The attached document was delivered to the Point Beach NRC Resident Inspector Office on July 10, 2013, by Point Beach licensee personnel and provides information on heights of components and potential performance impacts from design basis flood waters. The document is considered as additional information to that provided in Point Beach's "Response to Inspection Report 05000266/2013011 and 05000301/2013011, Preliminary Yellow Finding," dated June 28, 2013. (ADAMS Ascension number ML13179A333).

REVIEW OF FLOODING VULNERABILITY REPORT FOR POSSIBLE CLB ENCROACHMENT

Purpose

D-07, -08, -09

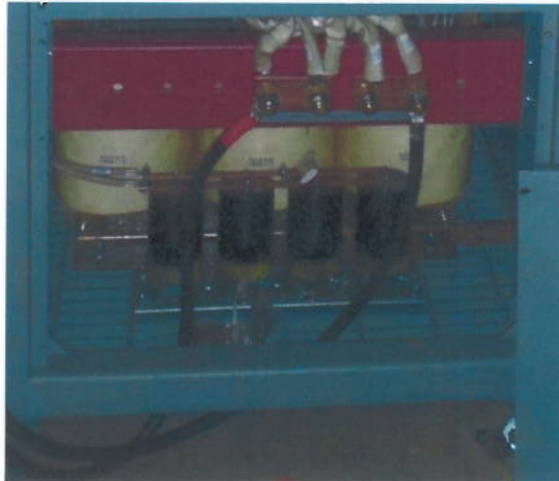
However, while electrical components that may be wetted reside higher in the cabinet than the bottom grill (~6-7" above the floor), water level high enough to cut off the air to the cabinet could cause eventual overheating and loss of the charger.

The above photo is the Ametek battery charger in the training building high bay. It is identical to D-07, D-08, and D-09. The bottom front panel has been removed to reveal the construction of the bottom grillwork, and the transformers and capacitors resting on top of the grill. Note the formed steel front rail that is approximately the same height as the grill.

The above photo is a close-up of the base of the D-08 charger (the other two charger installations are dimensionally the same). The bottom of the air inlet grill is at approximately 4.5" above the floor, with the bottom of the electrical components at approximately 6.5" above the floor. Therefore, while

wetting is not an issue, loss of cooling air is a potential problem. This condition was documented in AR 01881477 on 6/11/13 for further evaluation.

D-01/D-02 Vital DC Distribution Panels

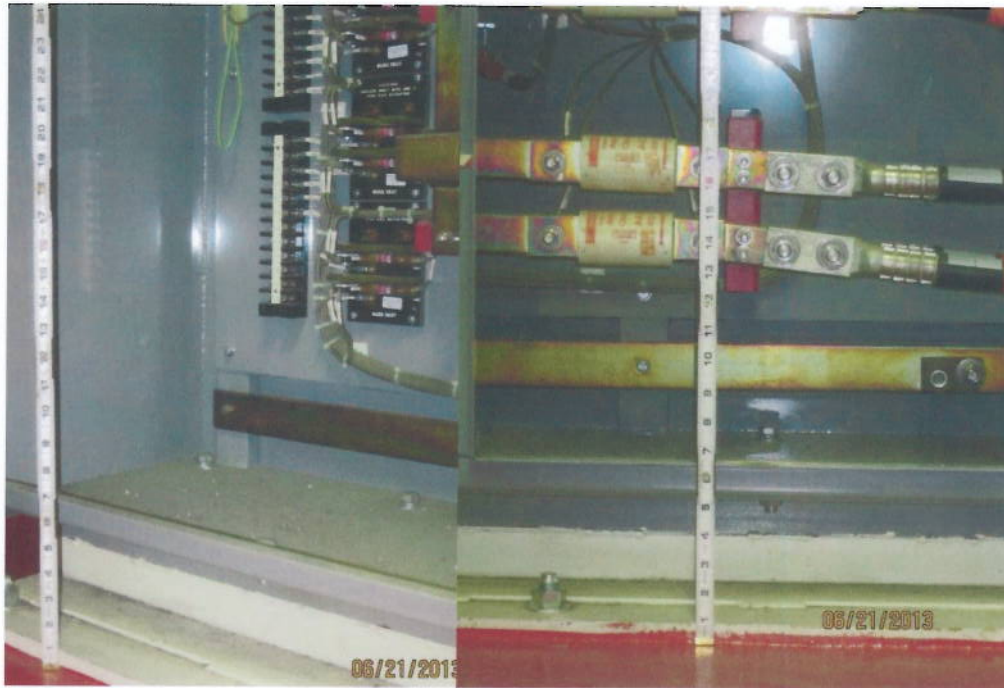
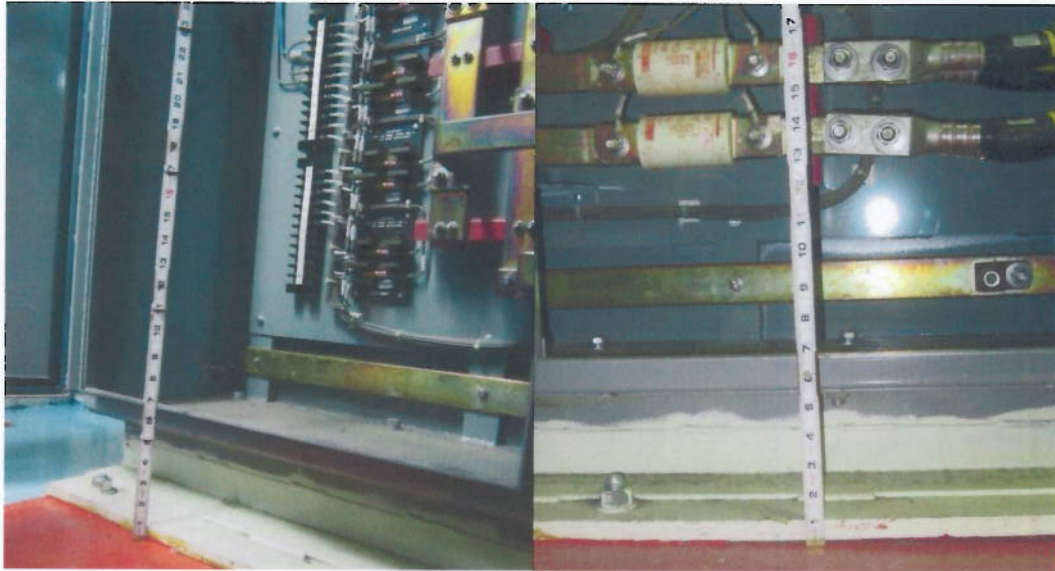
These panels rest on the 8' elevation floor inside the vital switchgear room. The front covers of the panels were removed and measurements taken to establish the lowest wetttable energized components. All were confirmed to be more than 12" above the floor.

In the photographs on the following page, the bus bar running across the bottom of the cabinets at approximately 9" above the floor is the ground bus, and is already connected electrically directly to the cabinet.

1-A05, 2-A05

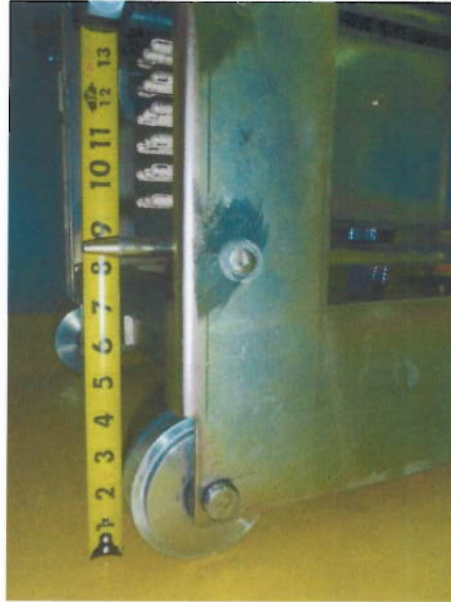
These are the two "A" train Safety Related 4 kV switchgear, one per unit. They are located in the vital switchgear room, and have identical cabinets for each breaker. The 4 kV stabs are located relatively high in the cabinet, with no high voltage components located low down. There is, however, a contact block for making up low voltage stabs that carry control and indication signals to and from the breaker assembly mounted close to the bottom of each enclosure.

The FVR indicated an elevation of 4" for these switchgear.

This is a close-up of the same auxiliary contact block showing the longer mechanical indexing pin at ~8.5" above the floor, and the auxiliary electrical stabs at ~9.5" and higher. Therefore, while the FVR lists an elevation of 4", there is no concern for loss of function from wetting by rising water until well above the license basis 5" elevation, and a flood vulnerability elevation of 9" above the 8' floor should be used.

C-034, C-035

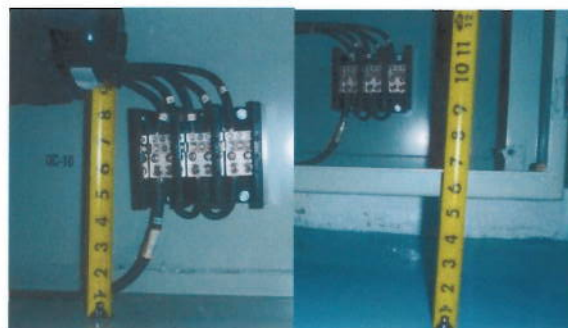
These are the G-01 and G-02 EDG Alarm & Electrical Panels located in the respective EDG rooms in the control building. They are listed in the FVR as being 5” above the floor elevation. The photographs below show the interior of cabinet C-034 (G-01 EDG Alarm & Electrical Panel). The cabinets rest on raised concrete pads that are ~4.5” inches high.

A review of existing photographs of the back of the cabinets found that they contain potential and current transformers, and that the components are higher than those in the front of the cabinets.

The lowest components vulnerable to wetting by rising water are located approximately 8" above the floor elevation, above the 5" indicated in the FVR, and above the design basis flood level.

Drain Traps

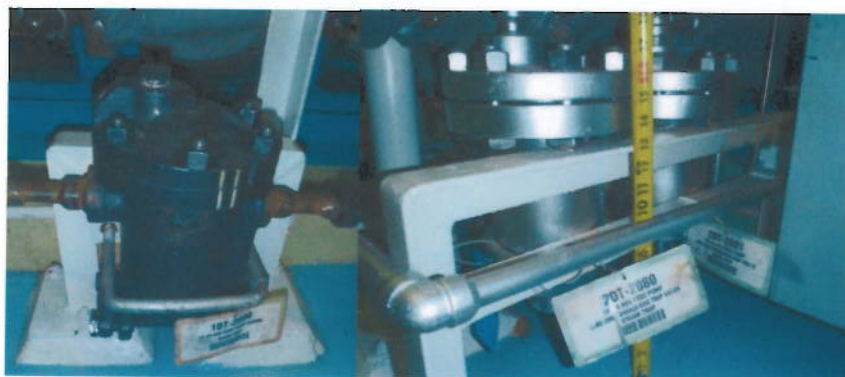
Several steam traps (1&2DT-2030, 1&2DT-2080, 1&2DT-2081) are listed in the FVR as being 6" or less above the floor elevation. This is factual. However, these components are sealed mechanical devices with no external moving parts, and no electrical components. In functioning, they rely on the differential pressure between the upstream side of the trap and the downstream side. Since this will

remain positive, even under flooding conditions, they will continue to function even if wetted or submerged. Below are photos of three representative steam traps.

1/2P-15A/B Safety Injection Pumps

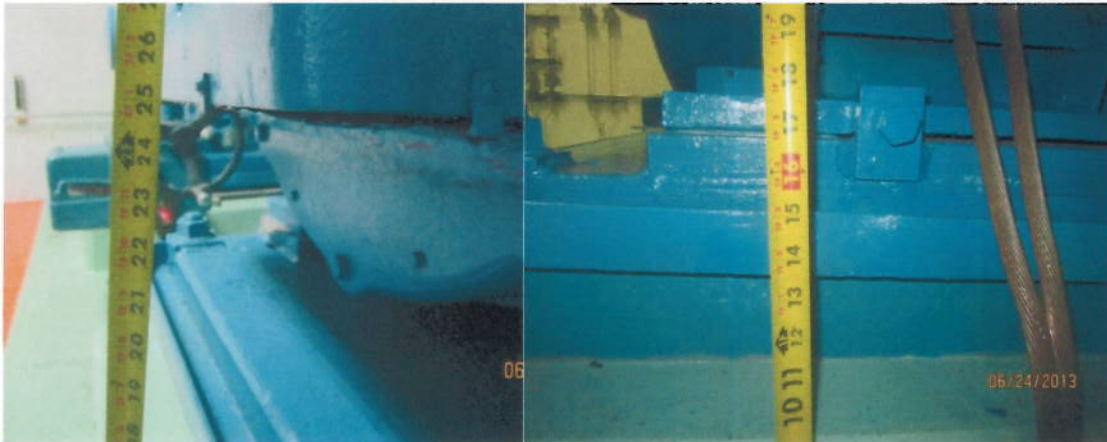
The PRA notebook on internal flooding uses a flood vulnerability elevation of 24" for these components, while the IPEEE assumed 12" would result in a loss of their function. A walkdown of these pumps found that the lowest vulnerable subcomponent would be the motors. These air cooled components have ventilation openings located at both 19" and 24" above the 8' floor elevation. Therefore, the lower level of 19" is the appropriate flood elevation to use for these pumps.

The first photograph shows the end-bell of one of the HHSI pump motors. The downward facing screened opening is 24-25" above the floor, while the lower tangent of the motor casing is slightly above the 19" elevation. The second photo shows the lower ventilation opening on the side of the motor casing, slightly more than 19" above the 8' floor.

1/2P-53 Motor Driven AFW Pumps

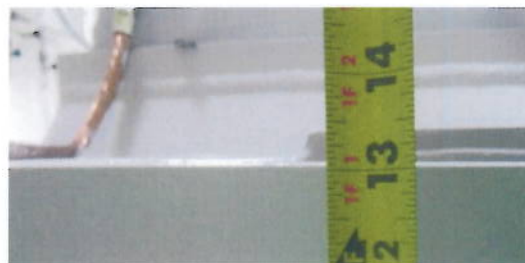
Additional walk downs were performed to more closely examine the installation. The pump motors are air cooled, with lower ventilation openings 7" above the top of the mounting baseplate:

The top of the baseplate is 13" above the 8' elevation floor, for a total height of 20".

The 20" elevation is consistent with PRA 7.1.
